re: Geotechnical Response to City Comments
Proposed Residential Development
100 Steacie Drive, Ottawa, Ontario
to: Brigil - James Battison - jamesbattison@brigil.com
date: June 1, 2026
file: PG5788-MEMO.04

PLAN VIEW:

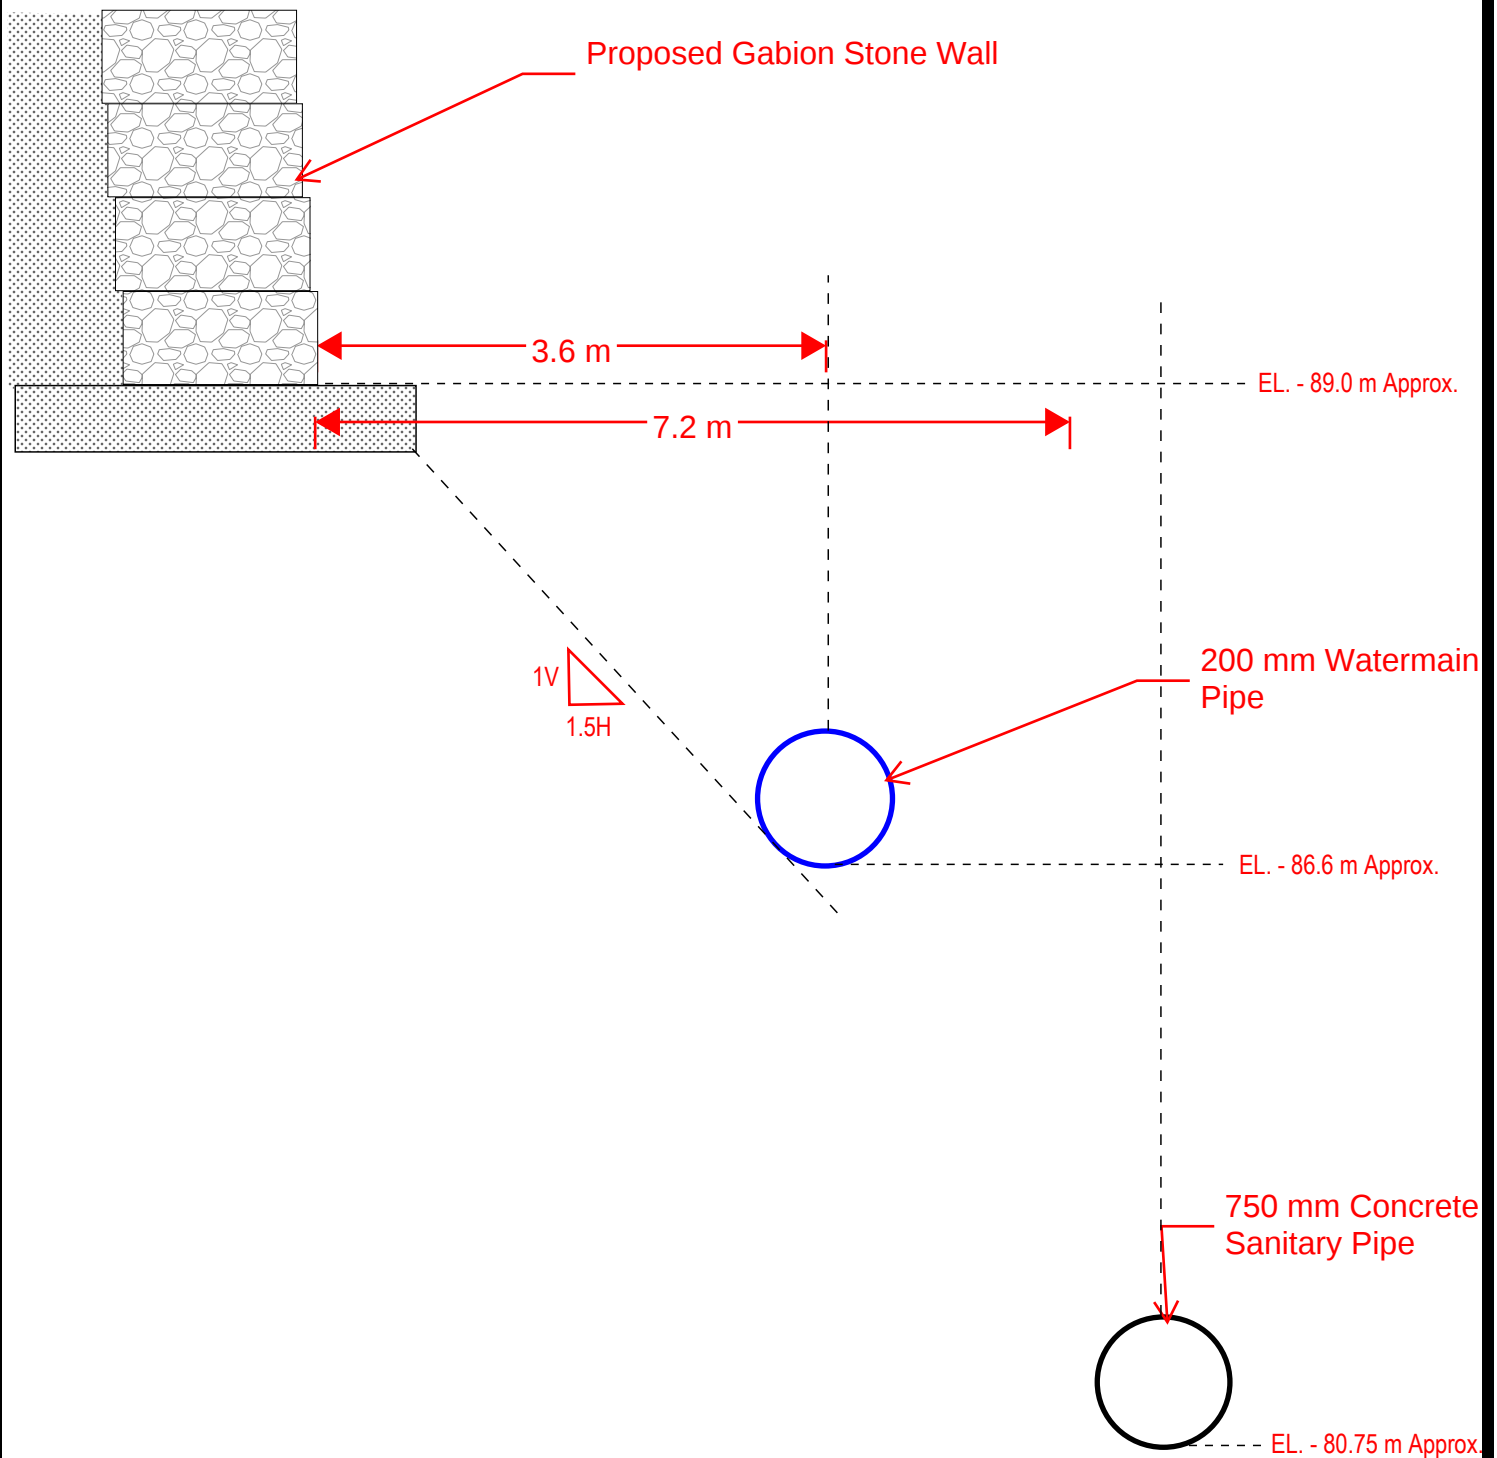
Comment 2: *Section 2.0 must confirm that the new watermain and existing sanitary sewer are located outside the lateral support zone of the proposed retaining wall PG5788-3.*

Response: Based on our review of the site servicing drawing Project No. 160401570 – Drawing No. SSP-1 Revision 8, dated March 24, 2026, the proposed watermain will be located outside the lateral support zone of the retaining wall.

The existing sanitary pipe is located approximately 9 m below the proposed retaining wall. Due to the depth of the existing sanitary service from the bottom of the retaining wall, no loading will be exerted from the retaining wall to the sewer. Furthermore, any maintenance to the deep sewer will require the use of shoring/temporary trenches boxes to be feasible which will further protect the service. Reference should be made to Figure 1 attached below.

- The proposed watermain will be located approximately 2.4 m below the proposed armor stone retaining wall and 3.6 m horizontally setback from the edge of the proposed retaining wall. Therefore, the proposed watermain will be located outside the lateral support zone of the retaining wall.
- Due to the depth of the existing sanitary service from the bottom of the retaining wall, no loading will be exerted from the retaining wall to the sewer.
- A suitable temporary shoring / trench box system will be required for any excavation for the proposed watermain or the existing sanitary pipe in the future.
